MAIN PURPOSE

The purpose of this memo is to inform that the product EN54 24V 5A FLX M has been discontinued and to provide guidance on replacement products. The document should ensure a clear transition to alternative solutions and minimize impact in ongoing and future projects

EN54 24V 5A FLX M Replacement Table

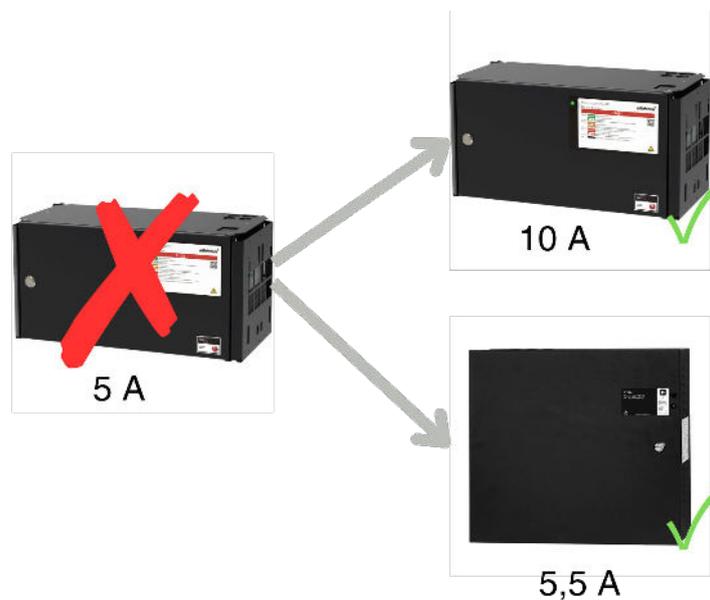
EN54 24V 5A FLX M has been discontinued. The product is discontinued when one of its main components is no longer manufactured. A redesign would require a new certification process, where the cost is judged to be disproportionately high relative to the demand of the product. As a replacement, we refer to the following products:

- EN54 24V 10A FLX M
- EN54 24V 5.5A MX M

- For installations where the FLX platform is used and where a higher output power is acceptable, the EN54 24V 10A FLX M. This is the most closely related option from a system and installation perspective.
- For installations where the MX platform is current, or where other system configuration is desired, the EN54 24V 5,5A MX M is recommended.
